Del Taco Restaurant, [H-11 / D063]

1525 Coors Blvd. N.W.

Del Taco restaurant Grading and Drainage Plan Re: Engineer's Stamp Dated 1-4-02, (H11/D63)

TCL Submittal for Building Permit Approval for Del Taco Restaurant

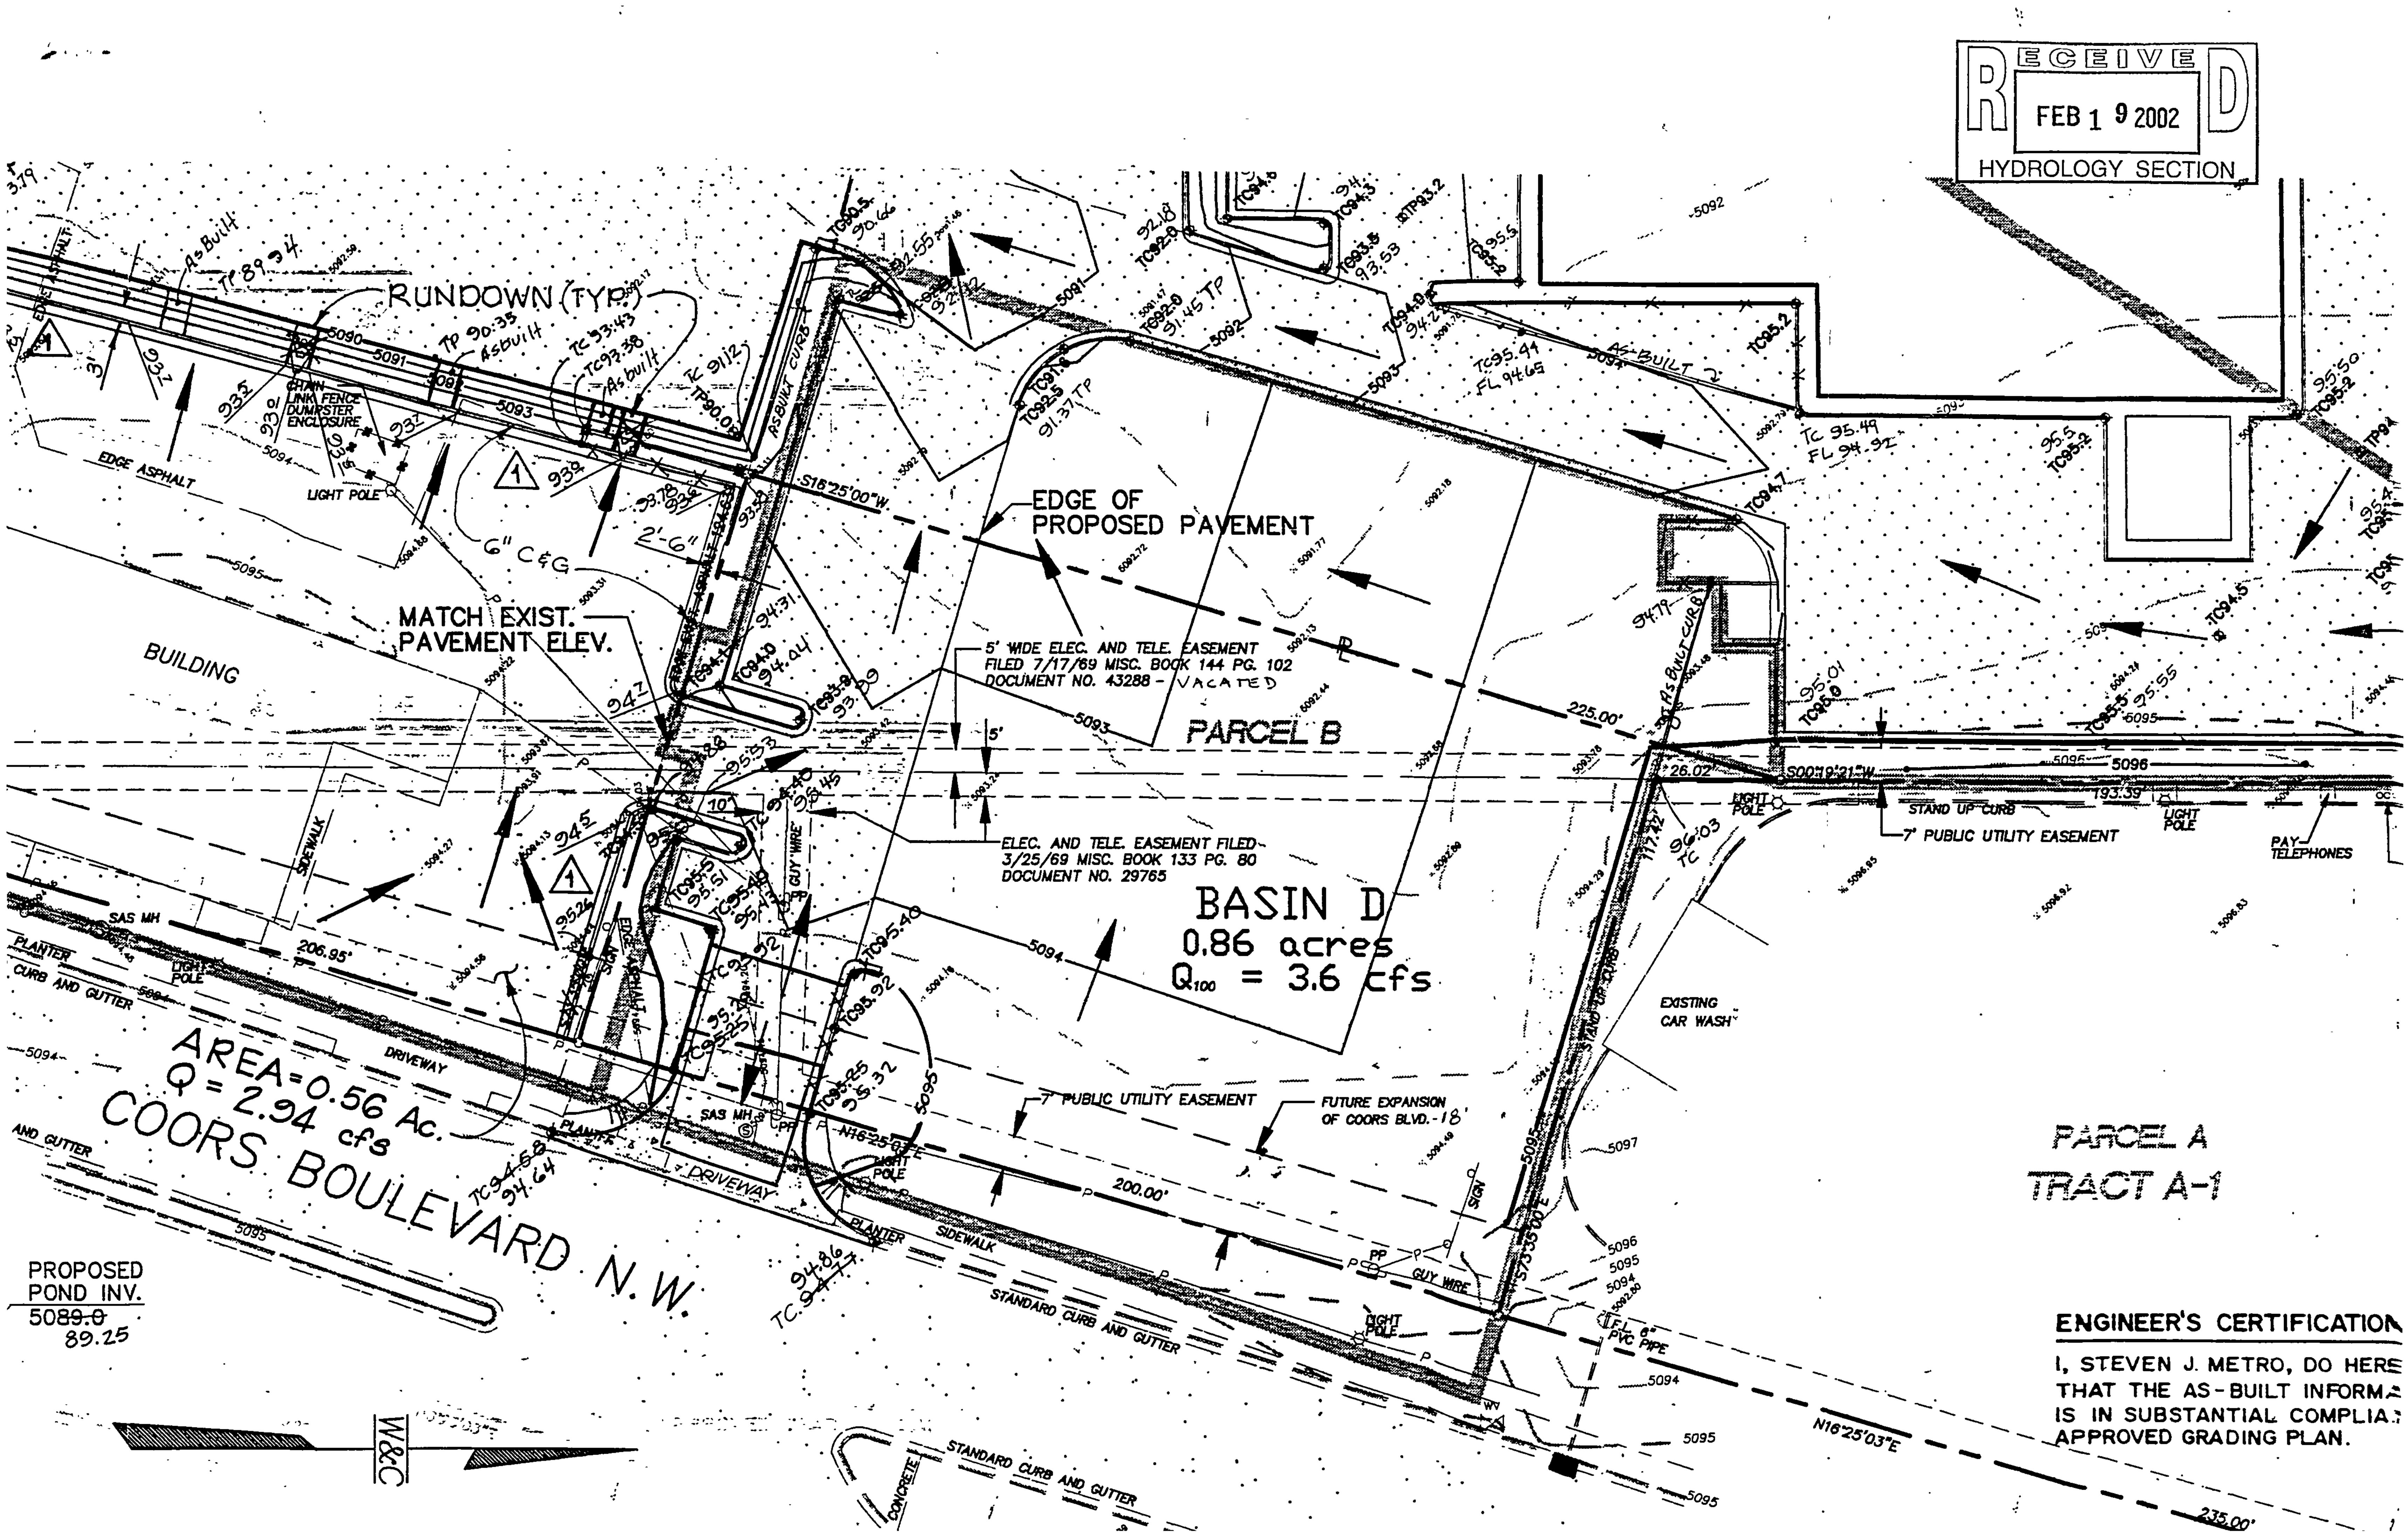
- Please address if there are any off-site flows. Also, quantify these flows.
- Please show pipe, inlet, or pond capacities for the downstream drainage system.
- Show where all flows go, including historical. A private easement agreement from all property owners will be required to discharge runoff across property line. An agreement will also be needed to verify who maintains the runoff across property lines.
- Please verify water block at each entrance.

TO: Carlos Montour	HYDROLOGY SEC
ORGANIZATION: City Andrology	
FROM: Phil Clark	
REGARDING: Del Taco - Plan dated H:11, D63	12/7/01
ITEM/MESSAGE:	
- As Requested & in Response to	Letter
- Received (dated 2/7/02) please find masterplan for Shell Oil	
- Find masterplan for shell oil	506
Unit 2. (H-11, D40, NICKOLSON Prop	=rhy)
- OUR padisite is Basin D' (Par	cel B)
Q developed	
- No off. site flows enter from	X6-76
(Exist. CAR WASH With RAISE Contains Run. off)	dcurb
Contains Run. off)	
D) 官区国口V国 Dhak you, 分加 PEB 1 9 2002 HYDROLOGY SECTION	Jell. File
